Shi Property, Preliminary Plan No. 120160280, (Resubdivision) including Preliminary/Final Water Quality Plan

Completed: 2/3/17

**Staff Recommendation:** *Approval with conditions*

*Figure 6 – Tree Variance Exhibit: one tree removal; three trees affected, but retained*

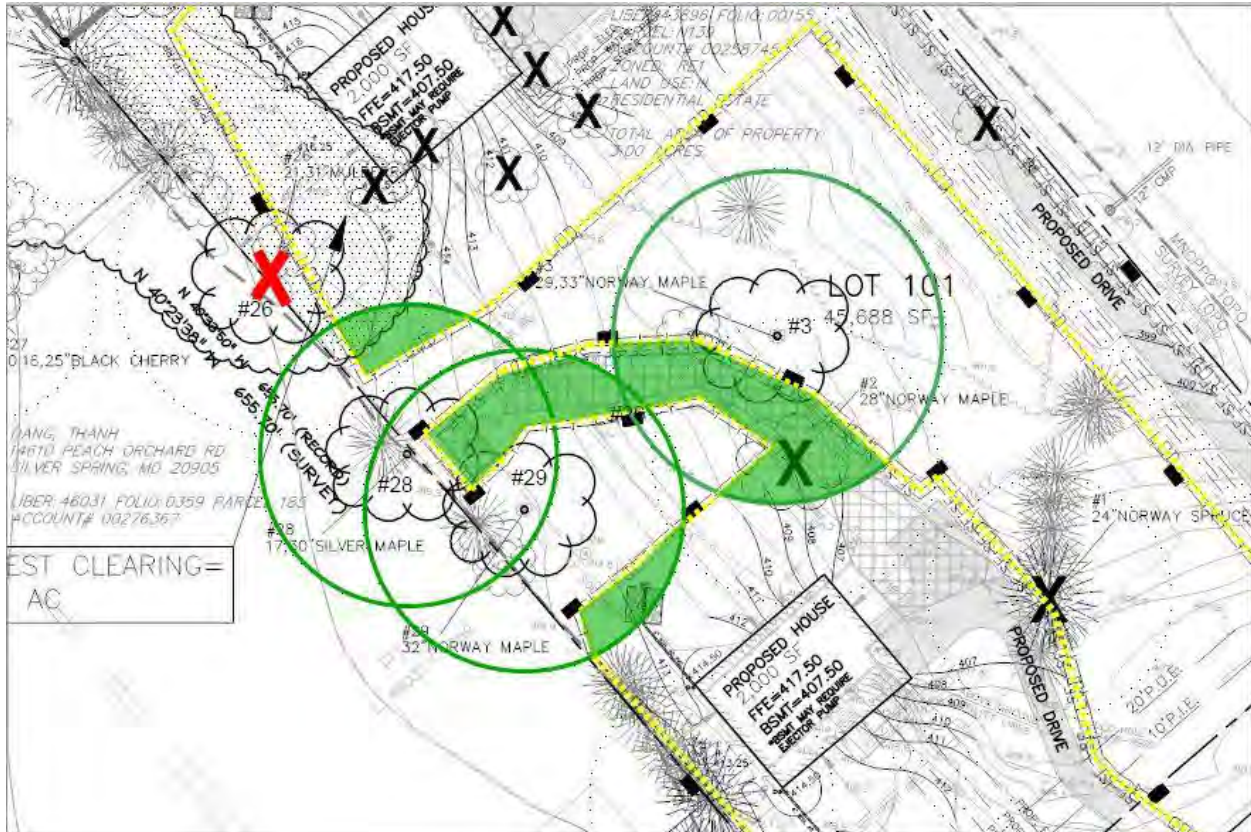
Variance Request – The Applicant submitted a variance request in a letter dated July 13, 2016, for the impacts/removal of trees (Attachment 11). The Applicant proposes to remove one (1) Protected Tree that is 30 inches or greater, DBH, and considered a high priority for retention under Section 22A-12(b)(3) of the County Forest Conservation Law. This tree, noted as #26 on the FCP, is a 31" DBH white mulberry in poor condition. It is located within the existing forest and will be removed as part of the grading for the construction of proposed Lot 102 (Figure 6).

The Applicant also proposes to impact, but not remove, three (3) Protected Trees that are considered high priority for retention under Section 22A-12(b)(3) of the County Forest Conservation Law. The critical root zones of these trees will be impacted during the removal of existing impervious surfaces and the grading of the proposed lots. Details of the Protected Trees to be affected but retained are listed in Table 2 and shown graphically in Figure 6.
